Review of U.S. EPA's Diesel Fuel Impact Model: Preliminary Comments

Sierra Research, Inc.

American Trucking Association, Inc.

August 28, 2001

Comparison of Observed & Predicted % Change for NOx

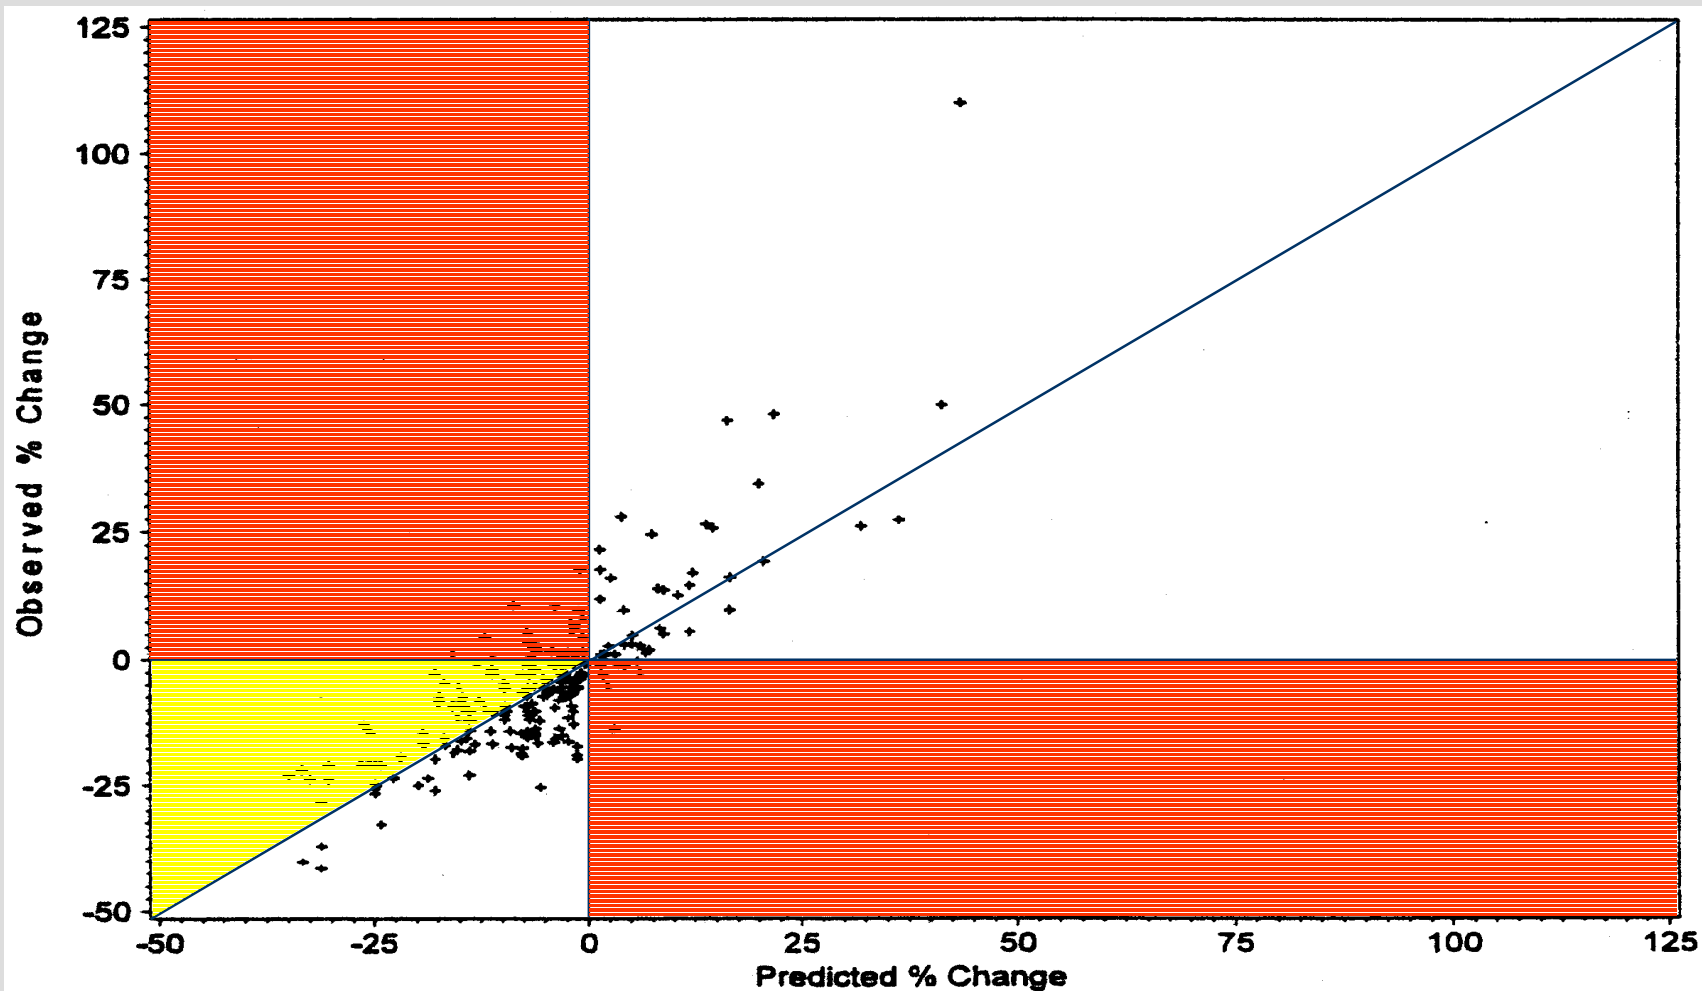
- SwRI report presents comparison of Observed % CE to Predicted % CE
 - Frequency of Predicted % CE that Differ in Sign from Observed % CE – Potential for Increased Rather than Decreased Emissions
 - Overprediction of % CE – Potential for Overestimating Emission Reductions
- Regression analysis of Observed % CE and Predicted % CE should show slope near 1 with good fit
 - **Not Performed**

- Predictions should agree with observed results for data not included in DFIM database
 - **Not Performed**
- Patterns in pairs of predicted and observed % CE with wrong sign or overprediction of observed emission reductions as a function of study, engine, or fuel should be investigated
 - **Not Performed**
